THE PORT AUTHORITY OF NY & NJ

ADDENDUM # 2

To prospective Bidder(s) on Bid # 47140 for Portable Train Stops for PATH Rail 115RE per Specifications and Drawings:

See attached revised drawing WS129 sheets 1 and 2 with additional dimensions and notes. Viewing them in color is advised.

SHEET 1 OF 2

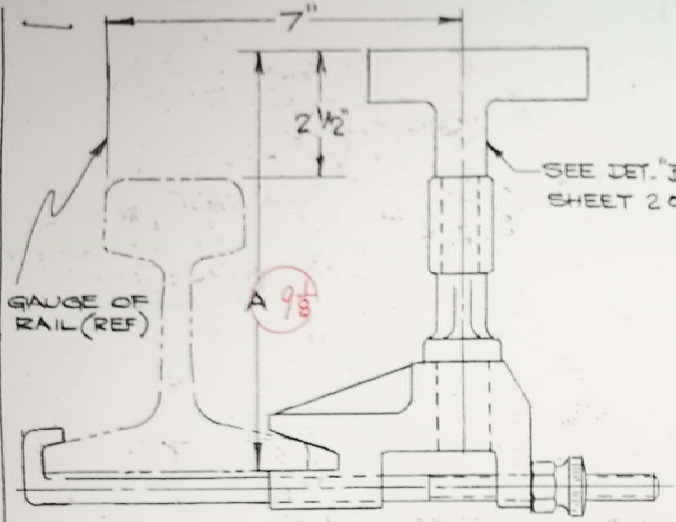
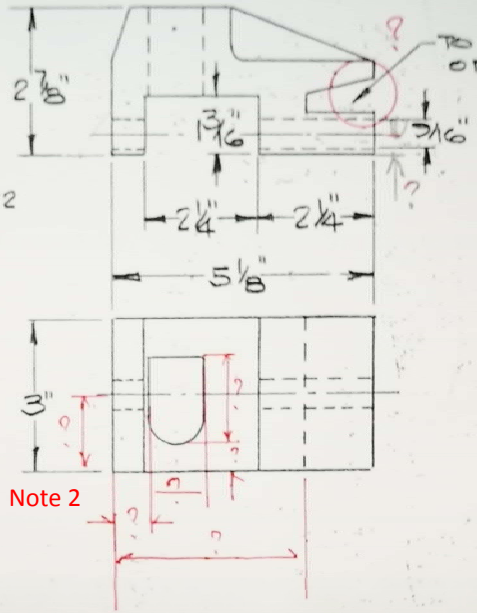
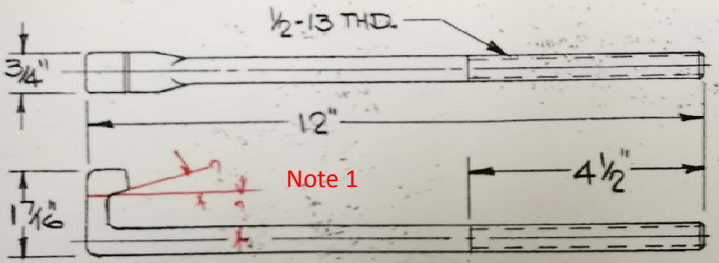
DIM. A
100 #ARA-B RAIL	9⅛"
115# RE RAIL	10⅛"

Note 1 – Manufacturer has to design these dimensions to fit the base of the rail section (100ARA-B or 115RE)
Note 2 – Manufacturer has to design these dimensions to fit male component per sheet 2 of 2 and distance requirements to gauge and top or rail section.

SHEET 2 OF 2

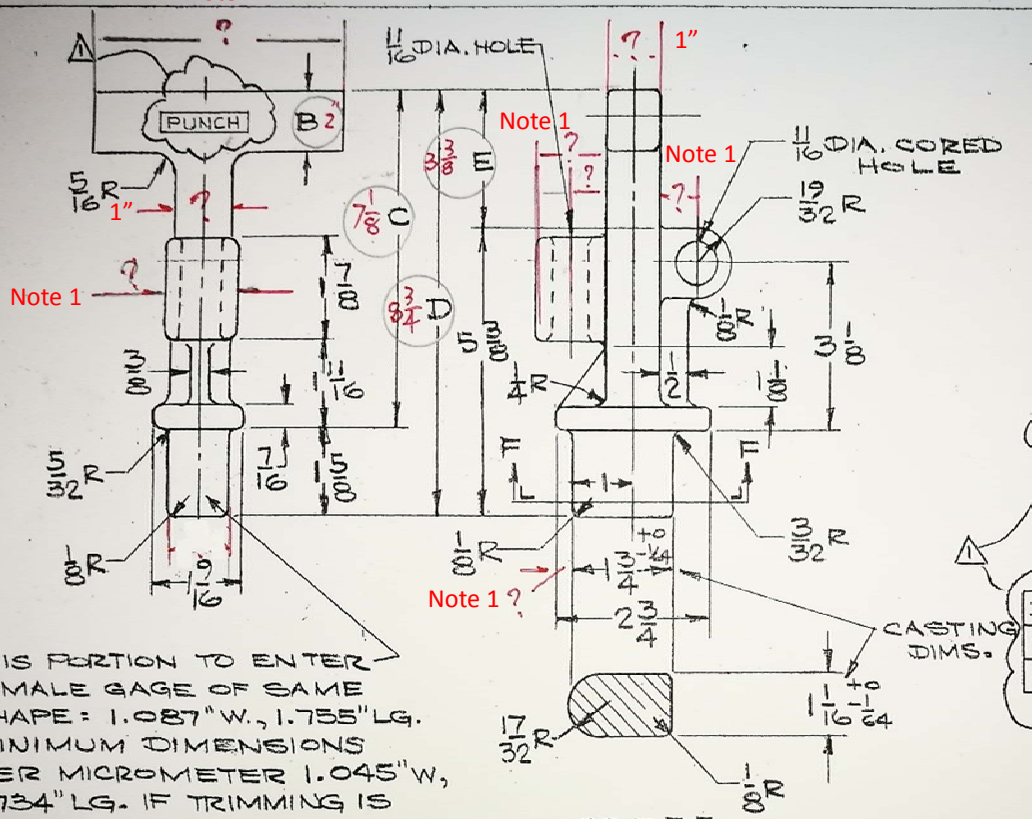
THIS PORTION TO ENTER FEMALE GAGE OF SAME SHAPE: 1.087" W., 1.755" LG. MINIMUM DIMENSIONS PER MICROMETER 1.045" W, 1.734" LG. IF TRIMMING IS NECESSARY, MAKE A SECURE SLIDING FIT.

Note 1 – Manufacturer has to design these dimensions to accommodate diameter of hole and/or radius of curve and fillet

Note 2 – Dimension shall be 2" towards the gage and 2.5" away from the gage of the rail section.
